Your Ref
Y/6/19/HH
Our Ref
PLAN-026830
Date
14/03/2019

Proposal: Listed building consent for construction of swimming pool within the setting of the yapton conservation area.
Site: Bonhams Farm House, Main Road, Yapton, BN18 0DX.
Y/6/19/HH

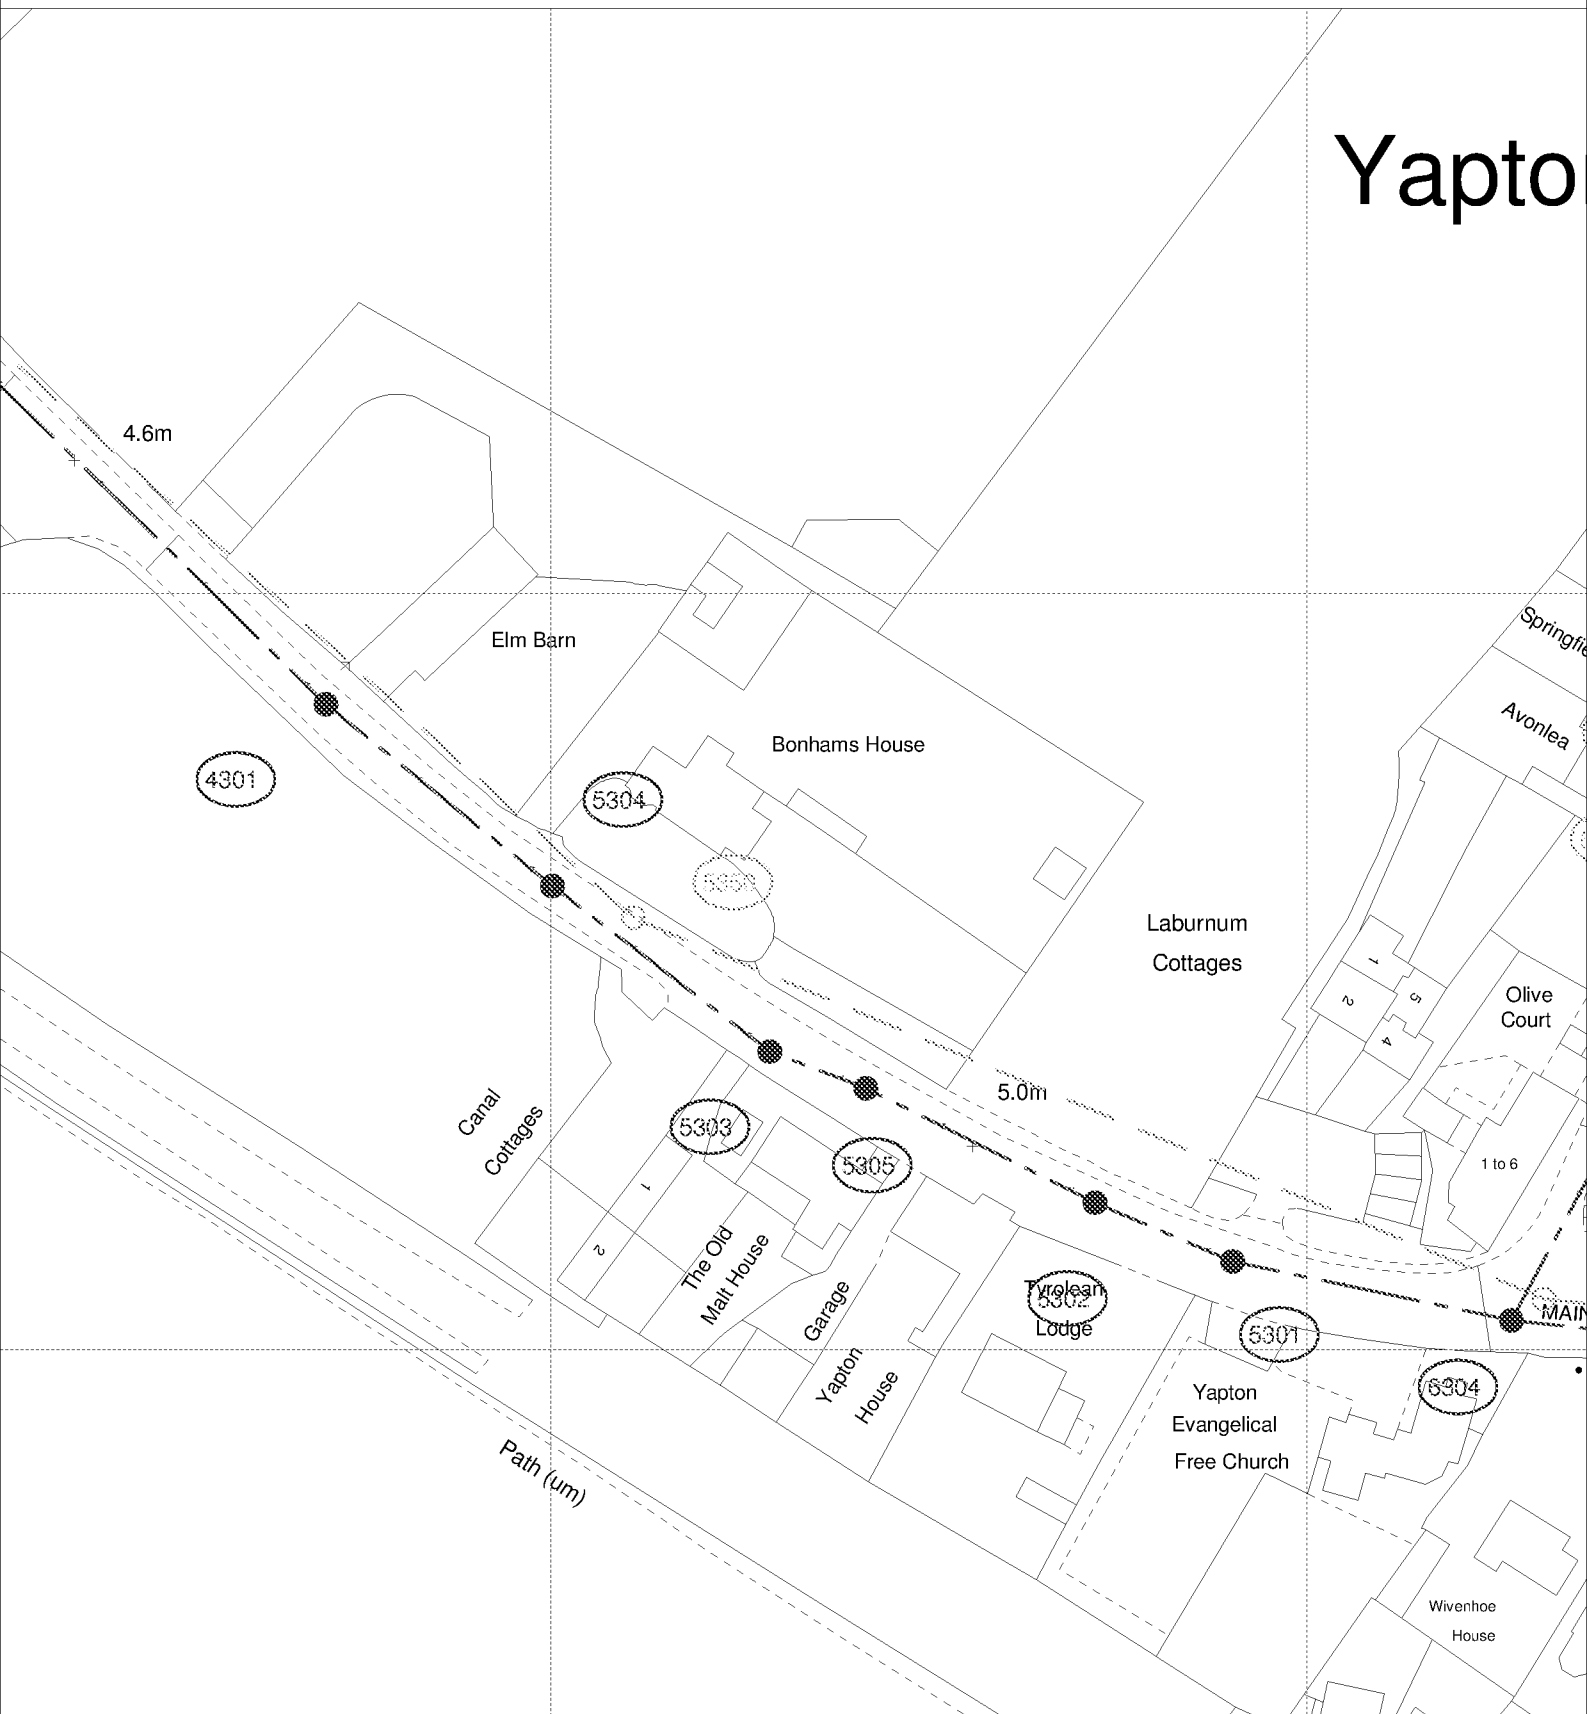
Due to surface water inundation issues in the Lidsey Catchment "The applicant is advised to adopt, where appropriate, the measures in the table "Practical measures to reduce the potential impacts of development".

Developer should look to protect the public sewerage system from inundation and infiltration, which contribute to flooding in unfavourable conditions.
